# Port Bouvard urban and canal development Stage 2, Northport and Eastport

Wannunup Development Nominees Pty Ltd

Report and recommendations of the Environmental Protection Authority

Environmental Protection Authority
Perth, Western Australia
Bulletin 671
January 1993

Figure 2: Proposed reclamation associated with Eastport

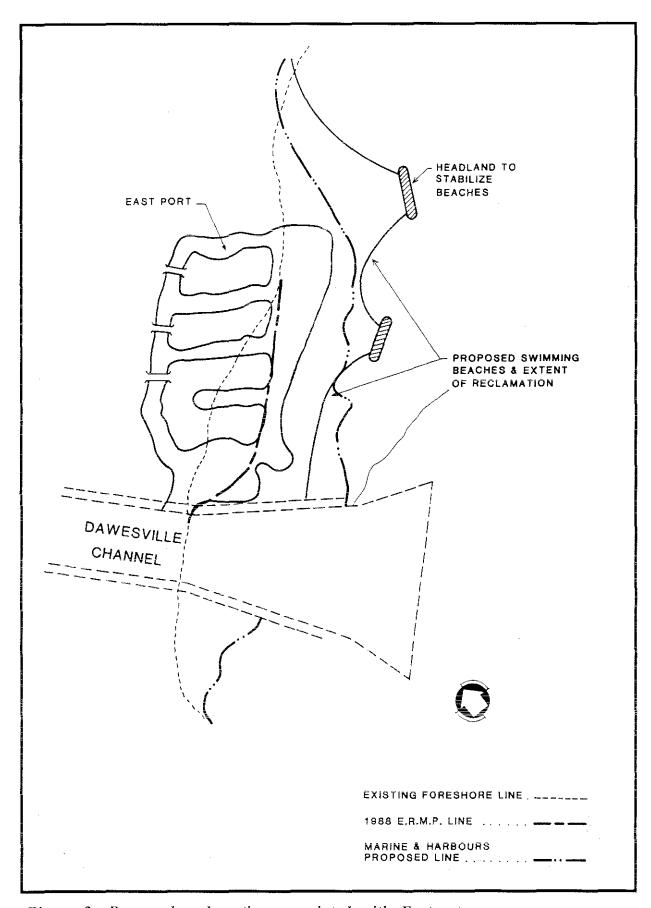
Concern was expressed in some submissions in relation to loss of estuary bed through the construction of the marina and canals. It is considered that the estuary beach proposed to be formed by the additional reclamation proposed will only replicate existing conditions (i.e. beaches proposed will provide access to shallow areas of estuary which already exist at present).

One submission stated that the actual area of land proposed to be reclaimed as part of the Eastport development was unclear within the PER, particularly in reference to the EPA's assessment of the additional area of estuary proposed to be reclaimed by the Department of Marine and Harbours in July 1992 (Bulletin 640). Some submissions also claim that the area proposed to be reclaimed as described within the PER (over 39ha) was contrary to recommendation made by the Environmental Protection Authority in Bulletin 640 that 'the area of estuary to be filled and reclaimed, including any artificial waterways should not exceed 25ha'.

The current proposal for Eastport as described within the PER is dependent upon the reclamation of an additional 11ha of estuary beyond that found environmentally acceptable by the Environmental Protection Authority following an assessment of an 'Extension of estuary foreshore reclamation associated with the construction of the Dawesville Channel' by the Department of Marine and Harbours in July 1992 (Bulletin 640).

The Authority notes that as the reclamation actually involves the filling of a portion of the estuary, it will therefore remove part of a public resource, i.e part of the Peel Inlet-Harvey Estuary estuarine system. Implementation of the Eastport development as proposed would necessitate reclamation of an area of estuary and utilise an area of reclaimed land for a private canal estate.
